**INSTITUTION:** University of Ontario Institute of Technology  
("Ontario Tech University")  
**TITLE:** Shawenjigewining Hall Interior Renovations  
**NO.:** RF POT04072026  
**ADDENDUM NAME:** Questions and Responses  
**ADDENDUM NO.:** 2

**Project:** Ontario Tech University, Shawenjigewining Hall  
4th & 5th Floor Renovations  
40 Founders Dr., Oshawa ON

## **Addendum No. 2**

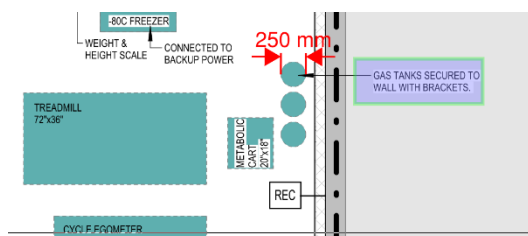
10) Confirm if communications, is a part of the project scope.

**RESPONSE:** AV/IT Cabling and PA System included in Cash Allowance. Refer to General Requirements 01 10 00 for base building contractors.

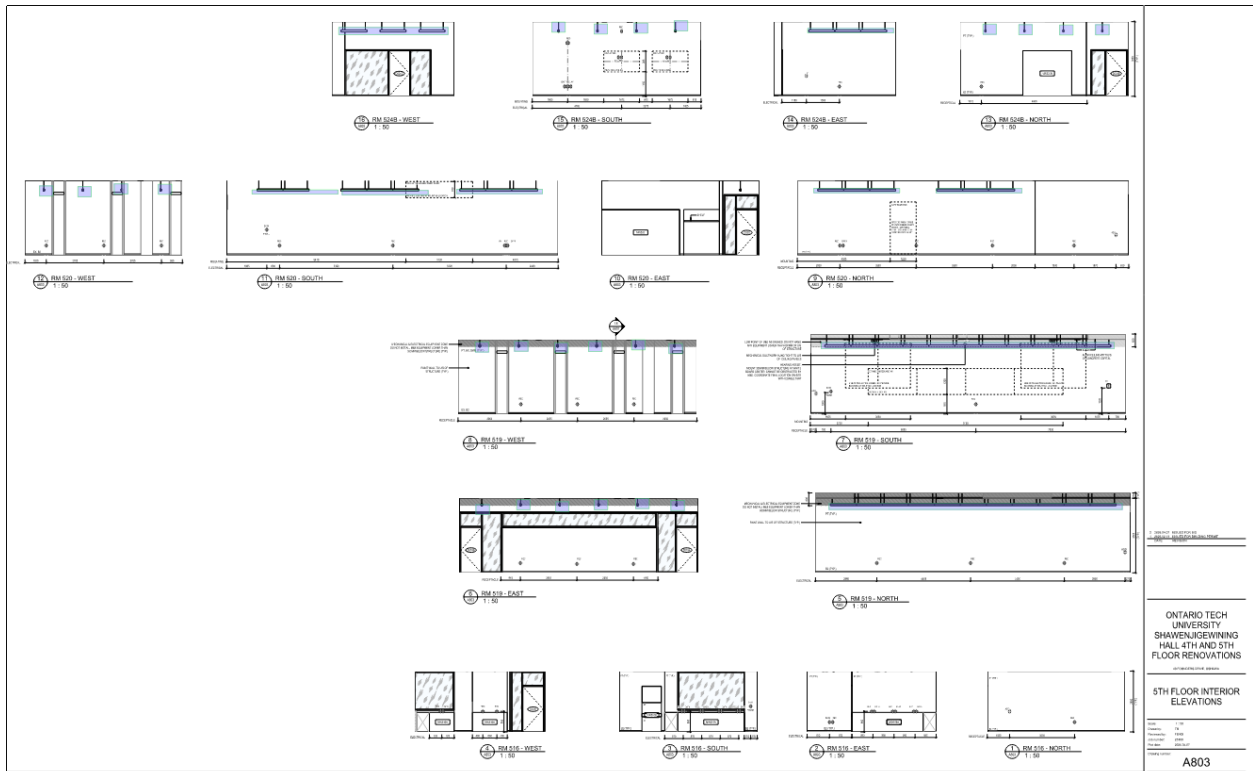
13) Misc Metals: Please clarify: Brackets of gas tank per A206 (Size, material, profile, finishing...)

**RESPONSE:** Gas tanks and brackets are supplied and installed by owner. Refer to coloured legend on drawings A205 & A206 FFE Plans for FFE “Owner Supplied and Installed”, “GC Supplied and Installed”, and “Owner Supplied & GC Installed”.
